Intel[®] 80314 I/O Processor Companion Chip

Specification Update

| *July 2004*

Order Number: 273759-006

Figure 1. Power-Sequencing Requirements

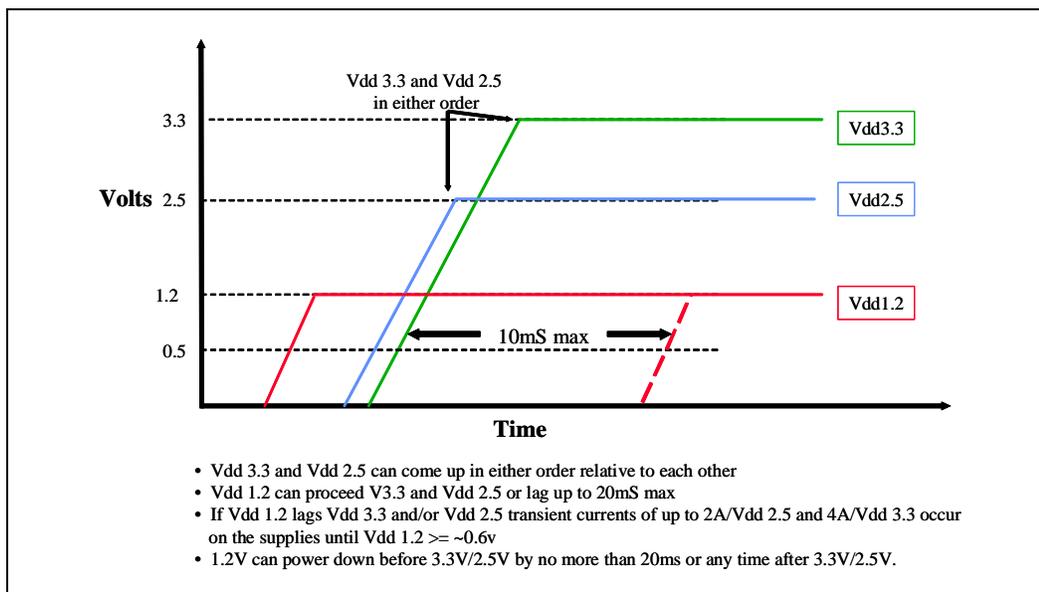
7. Power-sequencing requirement

Issue: The power-up and power-down sequences of the 80314 1.2 V/2.5 V/3.3 V supply rails has been revised from version 003 and 004 of this specification update. The power sequencing requirements initially presented in version 003 were designed to avoid transient current draw that could appear on the 2.5 V/3.3 V supply rails. Further investigation has determined that no current transients occur when the 1.2 V supply is ramped first. In addition, it is acceptable to ramp the 1.2 V supply after the 2.5 V and 3.3 V supplies as long as the lag is less than or equal to 20 mS. When the 1.2 V rail lags the 2.5 V and/or 3.3 V rail, transient currents of up to 2 A/V_{DD2.5} and 4 A/V_{DD3.3} can occur on the supplies until V_{DD1.2} >= ~0.6 V. The 1.2 V supply can power down no more than 20 ms before or any time after the 3.3 V/2.5 V supplies power down. These requirements are illustrated in Figure 1.

Affected Docs: *Intel® 80314 I/O Processor Companion Chip Design Guide* (Section 11.1)
Intel® 80314 I/O Processor Companion Chip Datasheet
